ADDENDUM NO. 2

TENDER NO. ICTA/OT/27/2021-2022

TENDER NAME: Connectivity of Schools to Internet

1. Router + switch high level schematic

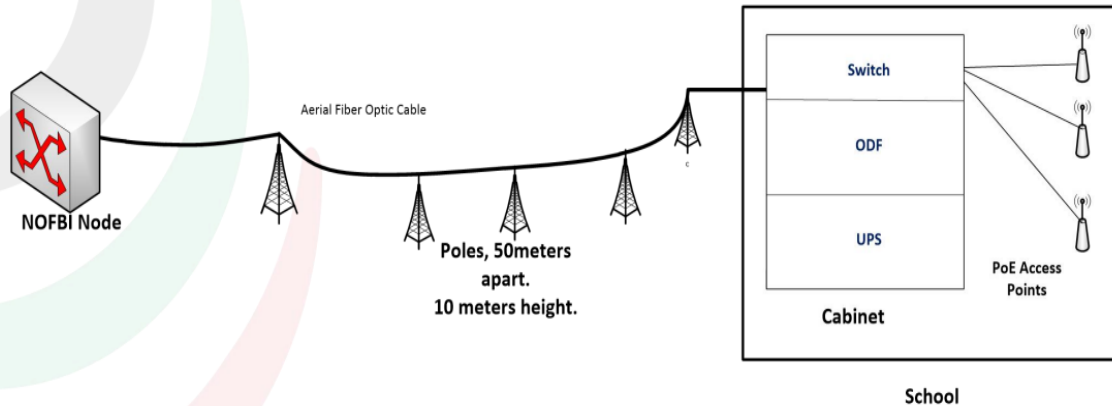
#	ITEM DESCRIPTION	ICTA RESPONSE/CLARIFICATION
1.	<p>a) Can you Provide a schematic Diagram Per school to understand and offer best products , considering the future of 10GEPON , POE in ONU's , Ring protection in Outdoor Switches etc.</p> <p>b) Item 4 -8 of the technical requirements - IEEE Standard for Ethernet SFP's are 1G - can you advise if we can provide SFP's which is comm across all vendors , instead of 1.25G SFP</p> <p>c) Item 12 - the Wireless AP has POE-IN or POE-Out ? if this is POE-IN , ONU in item 20 should have POE ports to connect Wireless AP or the ONU in item 20 should have Wifi matching the AP's .</p> <p>d) Item 2 IP Switch - Is out understanding correct - (4 10/100/1000 BASE-T(X) RJ45 ports and 4 1000 BASE-X SFP slots. 3. Up to 4 802.3af/ 802.3at Power over Ethernet ports, with maximum 30W) - in total 12 Ports , 4 with POE, 4 Without POE and 4 SFP + based</p> <p>e) Item 3 IP Router - Should a Layer 3 Switch which supports the mentioned Protocols is acceptable as the name suggests Router, the Specification is based on a "Layer 3 Industrial Switch"</p>	<p>A. In PDF attachment</p> <p>B. The minimum specification for SFP Data Rate is 1.25G.</p> <p>C. The specifications for the AP are amended to include: 10. Power: 240v/60hz AC 11. POE-IN</p> <p>D. The specifications for the IP switch are amended as follows: 2. 4 10/100/1000 BASE-T(X) RJ45 with POE (802.3af/at) ports and 4 1000 BASE-X SFP slots. 3. Deleted</p> <p>E. 4 x RJ45 with POE and 4 with SFP slots</p> <p>F. The bidder should quote for IP router that supports the given specifications</p>
